STAFF REPORT: SEPTEMBER 12, 2022 MEETING PREPARED BY: A. DYE

**APPLICATION NUMBER: 22-8012**

**ADDRESS: 1556 BAGLEY**

SCOPE: REHABILITATE DWELLING, ERECT REAR DECK

#### **REAR ELEVATION**

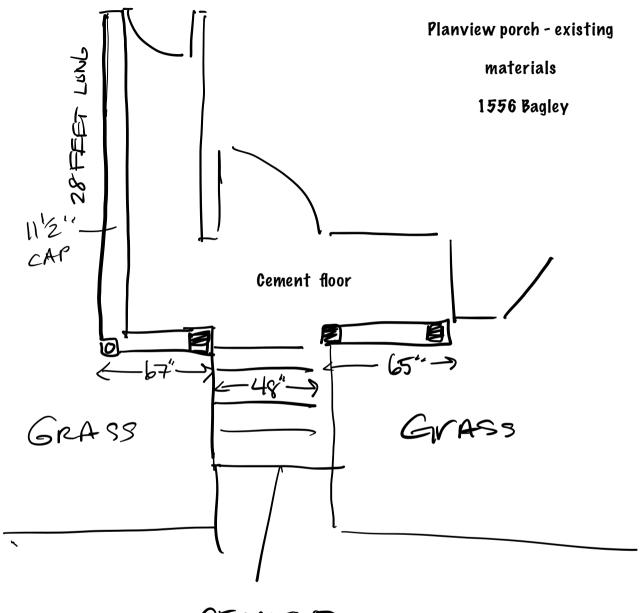
The outlines illustrate the approximate change to the rear wall for the sliding door, as well as the  $10' \times 13'$  wood deck with steps extending down on east and north sides. Door #7 is to be replaced with a half-panel/half-glass steel door.

The proposal is to extend the second-floor east elevation wall to the edge of the upper roof, increasing the headroom and square footage of the bathroom. Staff doesn't believe this new construction will diminish the historic architectural integrity of the house, as the footprint of the historic addition remains intact, along with the existing window opening.

- The rear elevation sliding door shall be wood, aluminum-clad wood or fiberglass frame; the cut sheet confirming all details, dimensions and finishes will be submitted for staff review.
- A site plan confirming the footprint of the deck, and a dimensioned detail of the railing to be constructed at the deck's west edge, will be submitted for staff review.
- Elevation drawings that detail the proposed extended wall at the second floor, as well as the enclosure of the second-floor door and related roof work, will be submitted to staff for review.
